**Comments on the Technical Memorandum For the Georgia Statewide  
Energy Sector Water Demand Forecast**

**Prepared by:  
Anna Sommer  
Sommer Energy, LLC  
19 ½ White Place  
Burlington, VT 05401**

**Prepared for:  
Southern Alliance for Clean Energy**

**June 22, 2011**

**Figure 5. U.S. Electricity Demand Growth and Population, 1952-2010 (3-year moving avg.)<sup>8</sup>**

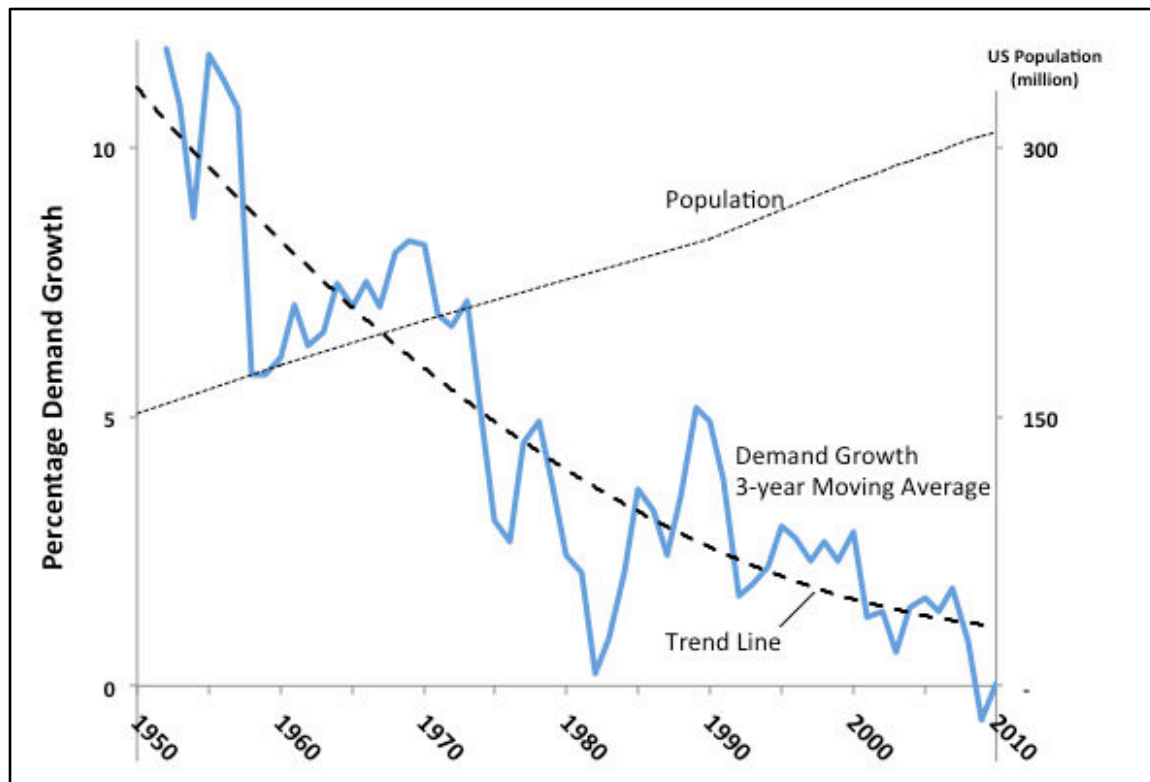
EPD’s use of population growth as a proxy for electricity consumption growth neglects the steady erosion of that relationship over recent history. As illustrated in Figure 5, electricity growth has slowed from an average of 9.8 percent in the 1950s to 0.5 percent in the 2000s even as the U.S. population has dramatically increased.

Because of this and because of the recent downturn in the economy, we view these rates of increase as highly uncertain. A better estimate than EPD's 1.64% figure might be the 0.9% annual growth rate forecast in EIA's Annual Energy Outlook 2011 for the southeastern region of the SERC Reliability Corporation (SERC), which includes Alabama and Georgia.

**Figure 6. Comparison of Baseline Power Needs and Corrected Baseline Power Needs Scenario Energy Forecasts**

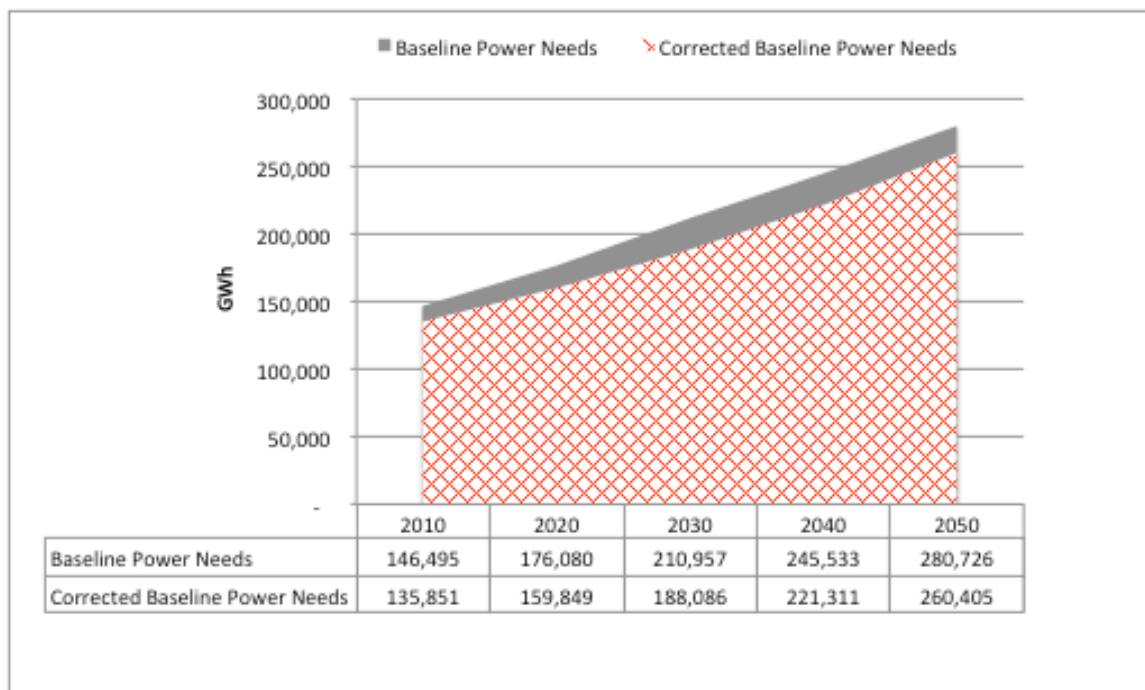
We've developed a "Corrected Baseline Power Needs Additional Capacity Scenario" that adopts the 2010 electricity consumption reported by Georgia utilities to the EIA: 135,851 GWh rather than 146,495 GWh as EPD assumes.

By 2050, the difference between these two forecasts magnifies to about 20,000 GWh. The effect of this change on water consumption will be driven by the energy resource mix that serves future needs and secondarily, by the type of cooling system used by thermal power plants included in that mix.

**Figure 7. Comparison of EPD Baseline Additional Capacity Scenario Water Consumption with and without Consumption for Once-Through Cooling (MGD)**

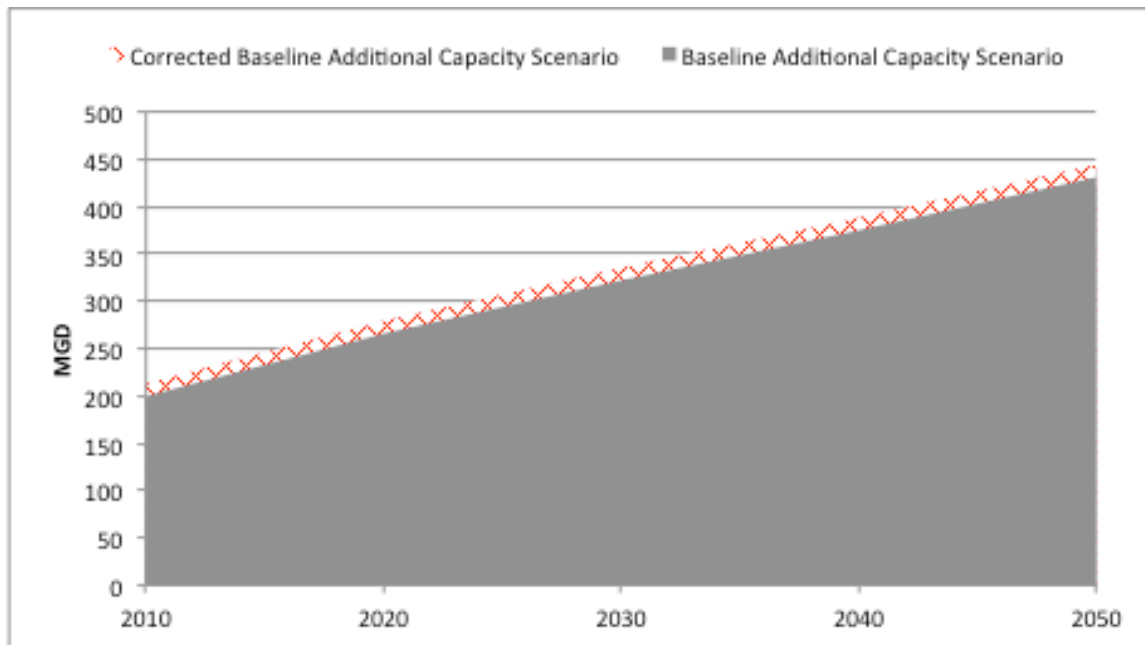
Another “simple” correction to EPD’s analysis is to assign a consumption value to once-through cooling systems. For example, the EPRI data cited in EPD’s report estimates that fossil fuel-fired power plants with once-through cooling systems consume 300 gallons per MWh generated. Under that assumption, EPD underestimates water consumption by thirteen to fifteen million gallons per day as demonstrated in Figure 7.

Note that the Corrected Baseline Additional Capacity Scenario illustrated in Figure 7 incorporates a different change here than what was shown in Figure 6. Figure 6 shows the change in GWh needed when starting from the proper 2010 baseline. Figure 7 simply shows the relative impact of adding in the consumption from once-through cooling systems. These two items were the only changes that were practical to implement given the limited data made public by EPD. We recommend EPD make additional changes, including accounting for FGD related water consumption, retiring older units, development of near-term capacity, and adopting a more realistic peak load forecast, which would produce an improved forecast.

**Figure 10. Water Consumption Demands, MGD**

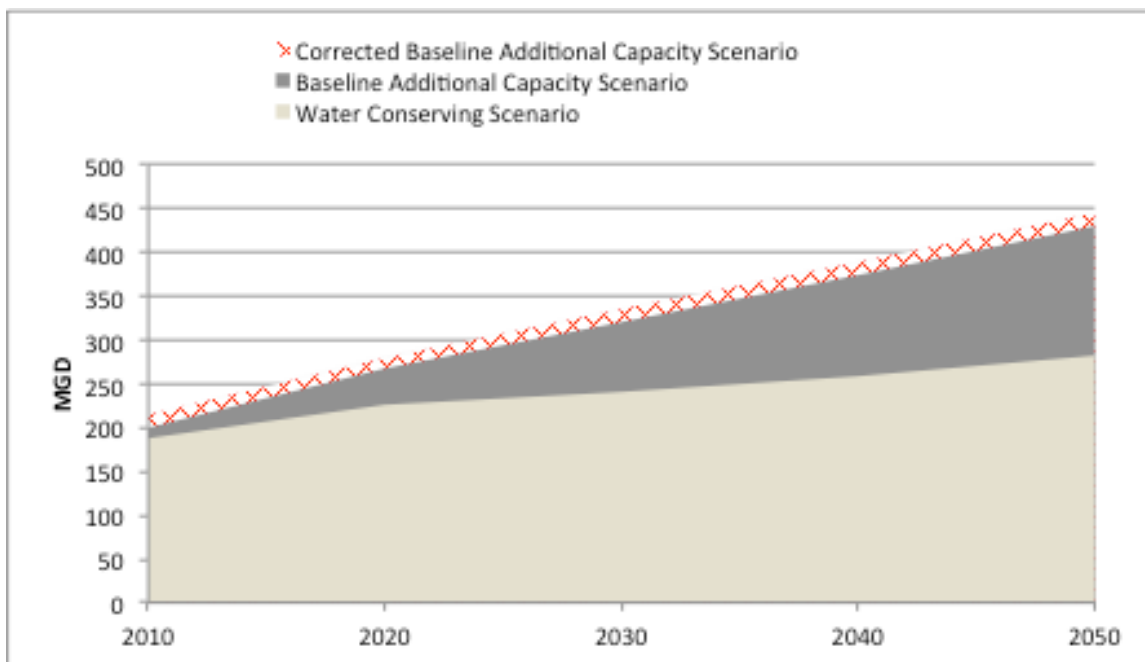
As illustrated in Figure 10, Georgia's energy needs can be met with far less water resource demand than suggested by the EPD Baseline forecast. Even under the Water Conserving Scenario, the electricity sector would consume additional water in the future. However, instead of more than doubling consumption by 2050, consumption increases nearly 50 percent by 2050. Both scenarios meet Georgia's generation demands but the water demands are radically different.
